# Access Compliance Report

## Public Rights-of-Way

Intersection ID: 10983	Main Street: E_22ND_ST	Cross Street: N_BREVARD_ST	Location: S
ADA ID: 21752FF77AEE	Ramp Type: PerpDiag	Initial Pass/Fail: Fail	Overall Compliance: No
		Severity Score: 10

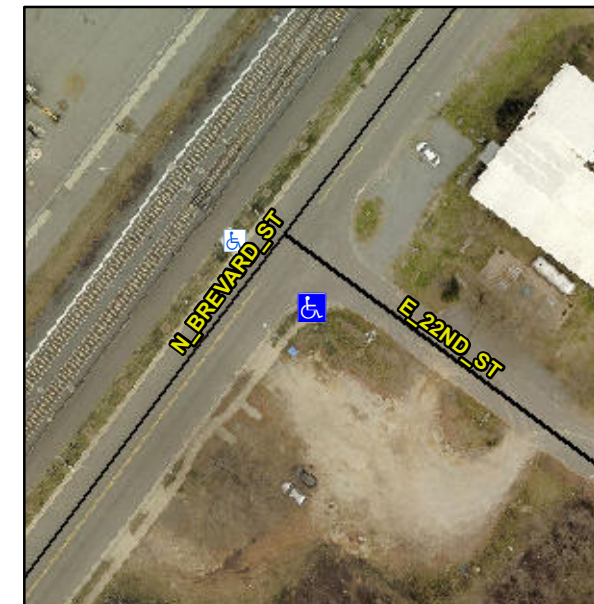
**Not Found, R304.5.1, R304.5.3**

Compliance	Description	Data	Compliance	Description	Data
N/A	Ramp Length (in)	109.0	Yes	Ramp Slope (%)	7.7
No	Ramp Width (in)	44.0	No	Ramp XSlope (%)	2.9
N/A	Flare Type LT	N/A	N/A	Flare Type RT	N/A
N/A	Flare Slope LT (%)	N/A	N/A	Flare Slope RT (%)	N/A
N/A	Flare Traversable LT?	N/A	N/A	Flare Traversable RT?	N/A
N/A	Landing Length (in)	N/A	N/A	DWS Provided?	N/A
N/A	Landing Width (in)	N/A	N/A	DWS Contrast?	N/A
N/A	Landing Slope (%)	N/A	N/A	DWS Length (in)	N/A
N/A	Landing X Slope (%)	N/A	N/A	DWS Full Width?	N/A
N/A	Landing Curb? (Y/N)	N/A	N/A	DWS Offset (in)	N/A
N/A	Shared Landing?	N/A			
N/A	Gutter Ponding?	N/A	N/A	Gutter Slope (%)	N/A
N/A	Gutter Lip Ht (in)	N/A	N/A	Gutter X Slope (%)	N/A
N/A	Painted X Walk1?	No	N/A	Painted X Walk2?	No
	X Walk 1 Direction	To NE		X Walk 2 Direction	To NW
N/A	X Walk 1 Width (in)	N/A	N/A	X Walk 2 Width (in)	N/A
	X Walk 1 Slope (%)	1.6		X Walk 2 Slope (%)	3.2
	X Walk 1 X Slope (%)	2.9		X Walk 2 X Slope (%)	0.7

**Remove & Replace Curb Ramp With Two New Directional Ramps or Equivalent.**
